STELLANTIS PARTS & SERVICES		Technical Service Bulletin (TSB) Seat Belt Height Adjuster		
REFERENCE:	TSB: 10-002-23 GROUP: 10 - Restraints	Date:	October 27, 2023	REVISION: -
VEHICLES AFFECTED:	2023 (M7) Jeep Compass This bulletin applies to vehicles built on or after August 23, 2023 (MDH 0823XX) and on or before September 21, 2023 (MDH 0921XX).			MARKET APPLICABILITY: <input type="checkbox"/> NA <input checked="" type="checkbox"/> MEA <input type="checkbox"/> SA <input type="checkbox"/> IAP <input checked="" type="checkbox"/> EE <input type="checkbox"/> CH
CUSTOMER SYMPTOM:	Customers may experience the seat belt position adjuster will not adjust to the maximum height position.			
CAUSE:	Incorrectly installed upper B-Pillar trim panel retaining clip.

Fig. 1
B-Pillar Clip

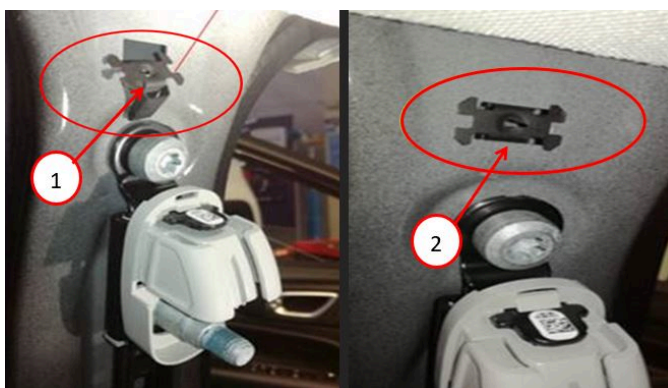
NOTE: Confirm the upper B-Pillar trim panel clips are installed properly [Fig. 1](#).

1 - Improperly Installed B-Pillar Clip
2 - Properly Installed B-Pillar Clip
